AVIONS PIERRE ROBIN

BULLETIN DE SERVICE
SERVICE BULLETIN

N° 90

Reinforcement of aileron/flap common support bracket
R 2000 all types, all Serial numbers.

FIG. 1

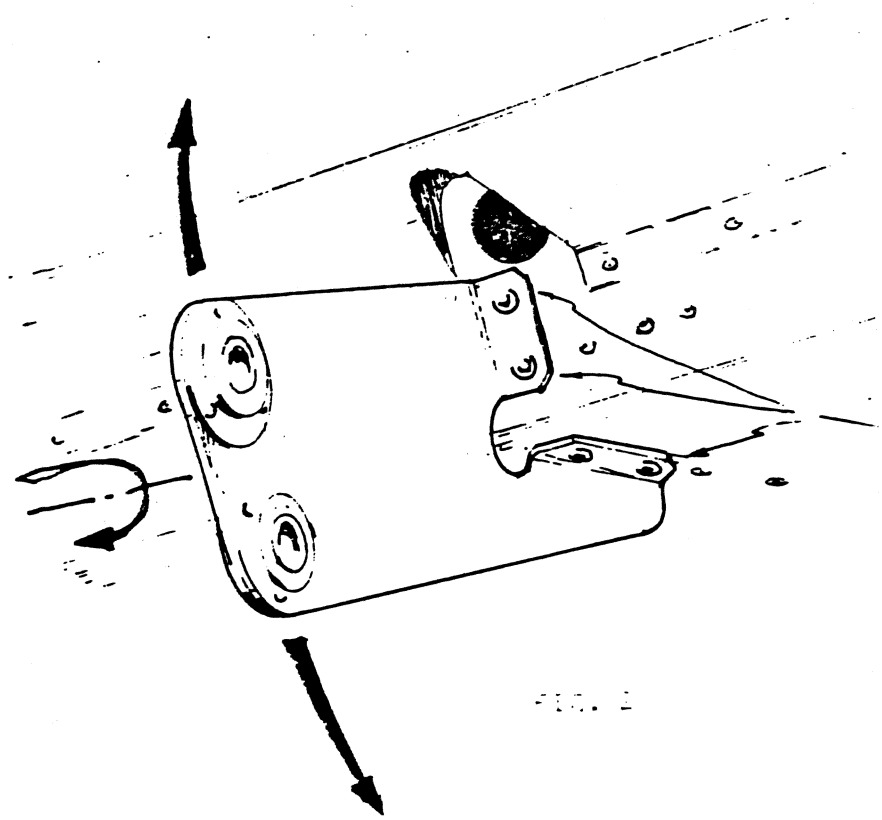
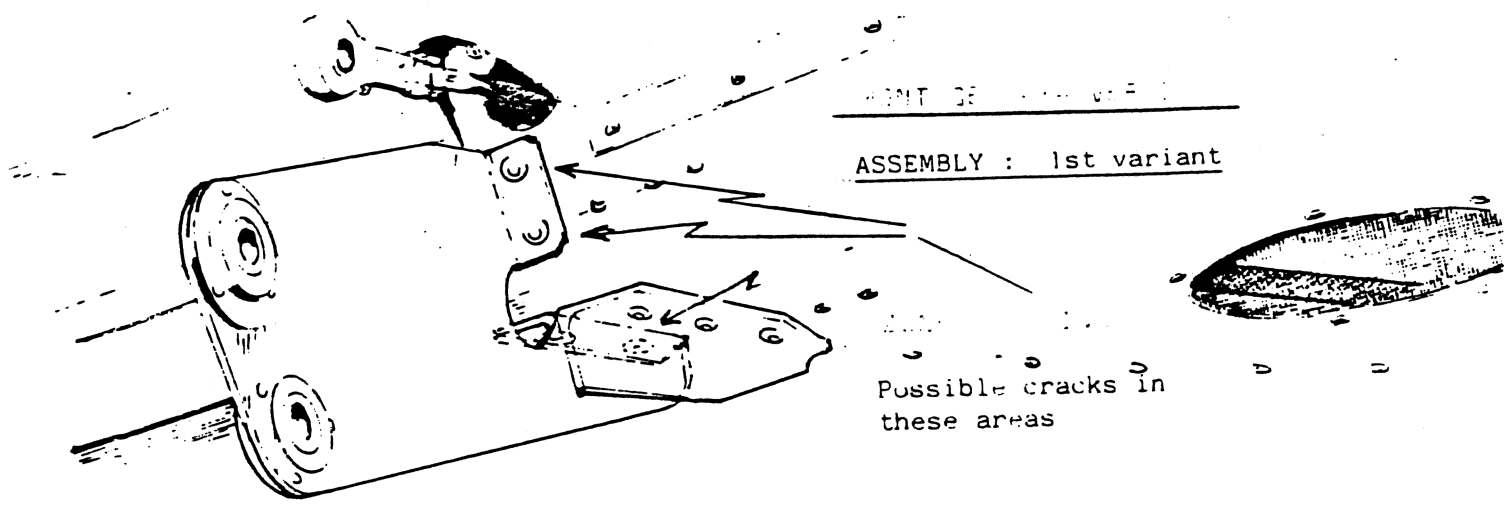
Cracks have been detected close to the attachment points of the RH and LH aileron/flap common support bracket and corresponding wing skin areas.

Within the next 50 flying hours following the receipt of this S.B. check the soundness of this attachment. To this end, manually apply an up-down load accompanied by a torsion load, as shown on figs. 1 and 2, to find the presence of possible cracks, loose rivets and/or separation of the bracket from the skin.

Possible cracks in these areas

- 1 If a defect is detected, embody the applicable A.P.R. modification (aileron/flap support bracket repair kit) before further flying.
- 2 If no defect is detected, renew the checks every 50 flying hours, until the aileron/flap support bracket is repaired. The repair kit must be fitted, at the latest, at the next Major Inspection.
